Intel[®] Atom[™] Processor E6xx Series

Specification Update

May 2012

Revision 012

Figure 10. 1U Natural Convection Heatsink Mechanical Drawing

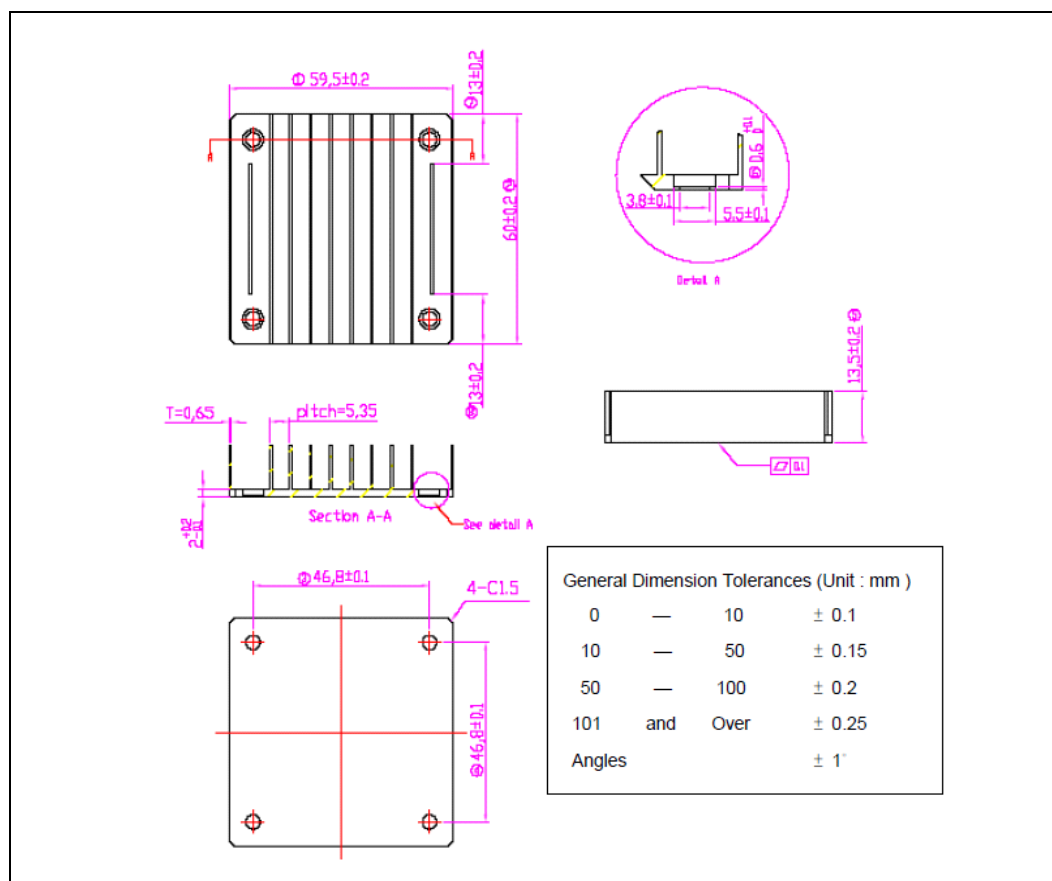
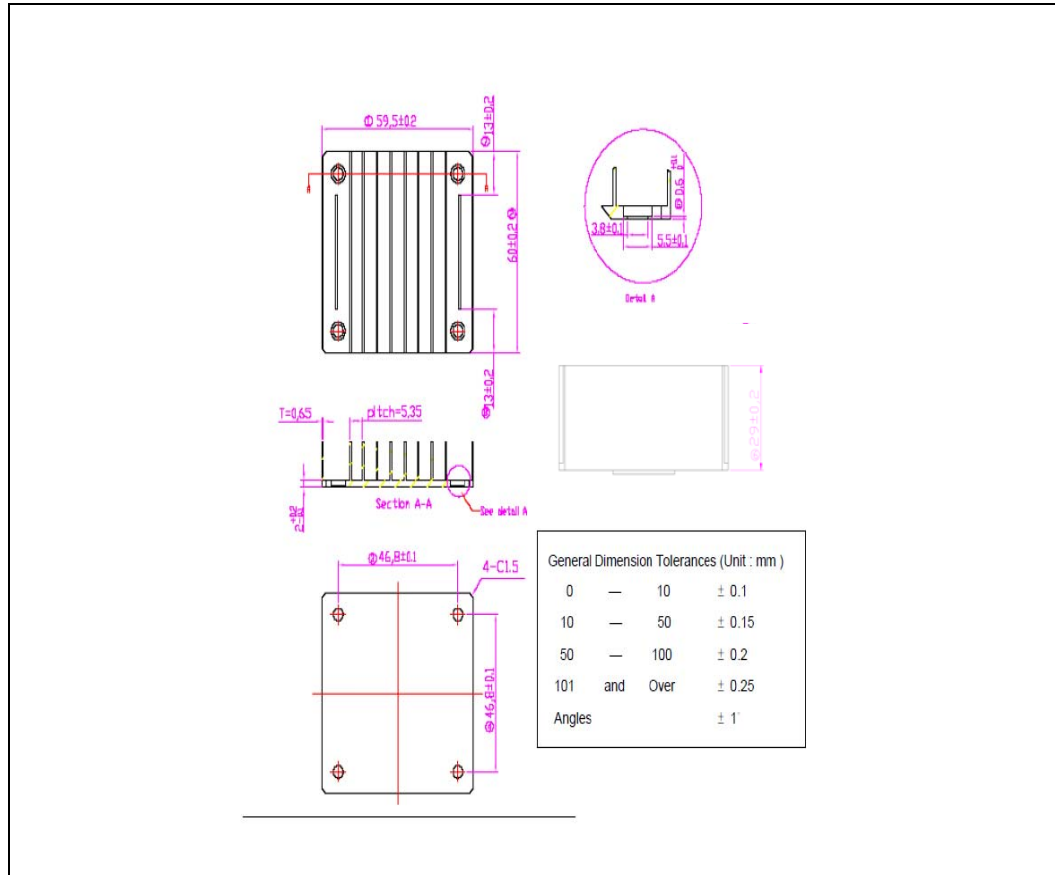
Issue: Heatsink height on Figure 10 “1U Natural Convection Heatsink Mechanical Drawing” has changed from 13.5 ± 0.2 mm to 29 ± 0.2 mm.

Affected Docs: Figure 10 “1U Natural Convection Heatsink Mechanical Drawing” of *Intel® Atom™ Processor E6xx Series Thermal and Mechanical Design Guidelines*, Rev 003.
